Kier response to the 15 points raised by Camden following the presentation of the CMP to Camden Councillors on the 31st May 2019.

Figure 5 - Visirail guard fence for use along the carriageway.

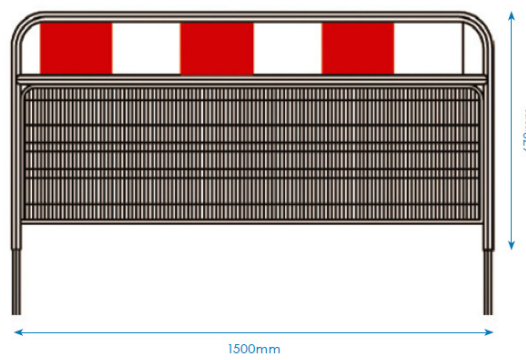
Point 9 – Specification of protective barriers

- A description and photograph of the proposed metal Mass barriers to be used is included within the CMP as submitted under section 22b. These barrier interconnect with each other and are inherently stable. They are linked via internal pins, are wind resistant and have an anti-vandalism design. Mechanical fixings will also fix the Mass barrier to the highway to increase their anchorage. The Mass barrier will have a Mass barrier Pedestrian Guard fence inserted into its top, these are also clipped together for added security and stability. Mass Visirail Guard shall be utilised where used on the carriageway. (A copy of the Mass Barrier specification is attached with excerpts below for ease of reference).

Figure 6 - Location plan for scaffold gantry above the public footway.

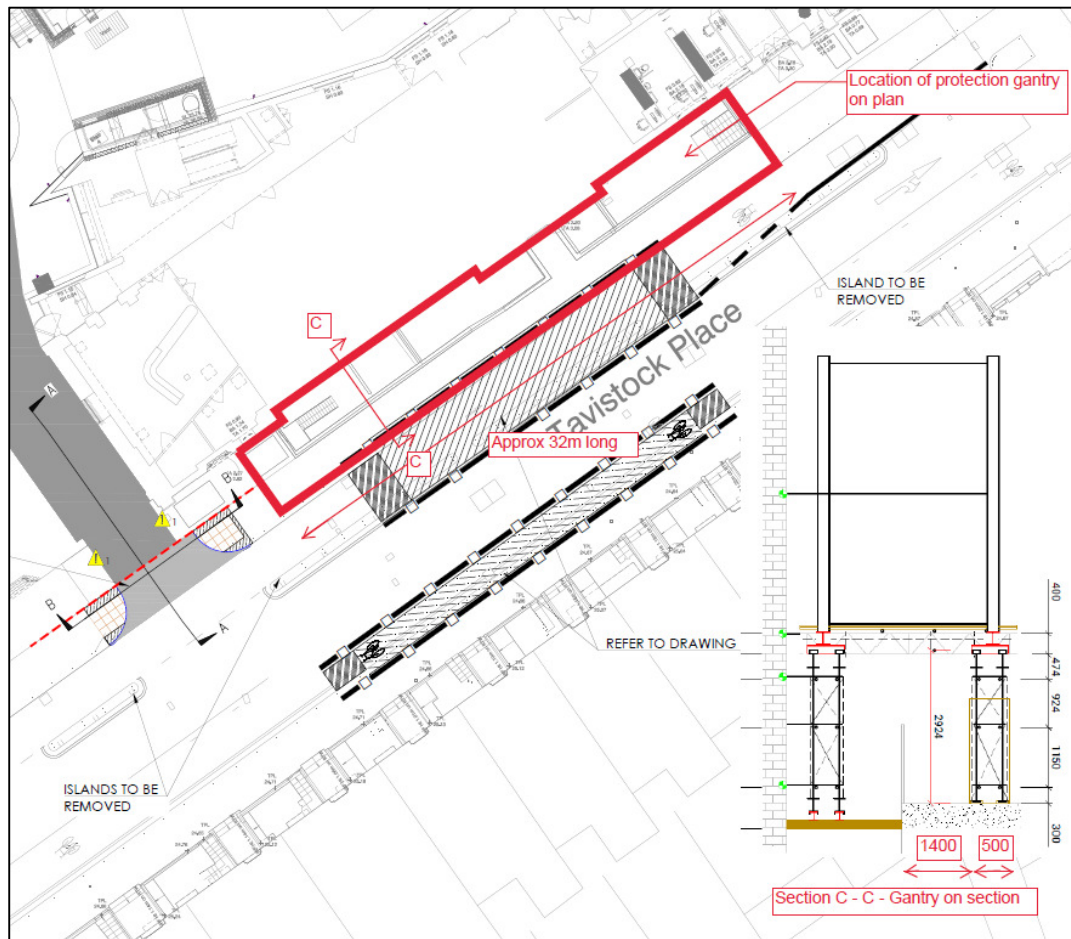
Point 10 – Scaffold gantry above the public highway

- The pedestrian gantry will be constructed from tube and fitting scaffolding and have a double boarded deck with a membrane placed between the 2 layers of boards. The outside legs of the gantry shall be hoarded in accordance with Camden’s requirements and will be

of the approximate dimensions of 32m long by 1.9m wide over the public footpath. The height of the gantry above the existing footpath levels will be approximately 2.9m. The location on plan, the height and the cross section through the gantry are shown on the below drawing (Figure 6).

Figure 7 - Luffing jib tower crane to be used with parked radius of 12m.

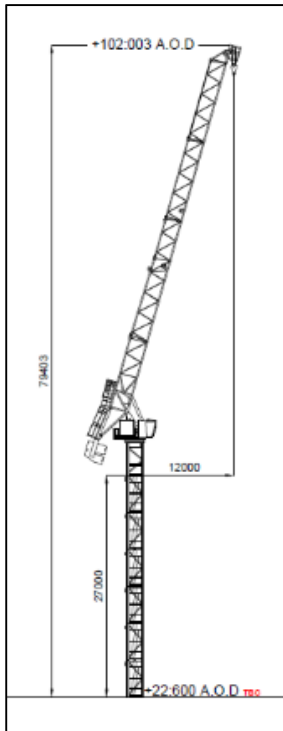
Point 11 – Tower crane details

A Luffing jib tower crane is to be used as per the excerpt below from drawing 4821-02 (Copy attached). This type of tower crane will prevent over sail of adjoining properties by setting the onboard computer to intervene when the working radius zones are reached, at which point the crane operator will jib up to reduce the working radius before being able to slew round. This is noted in the CMP under section 27b. The maximum working radius are shown on the below excerpt of drawing 4821-01 (Copy attached). It should be noted that over sail of the public highway will be required to be able to unload materials from flat bed vehicles parked in the unloading bay on Tavistock Place. Note that the onboard computer can be set up such that the radius is restricted to reaching only as far as the edge of the unloading bay. It will be necessary to obtain an over sail licence from Camden.
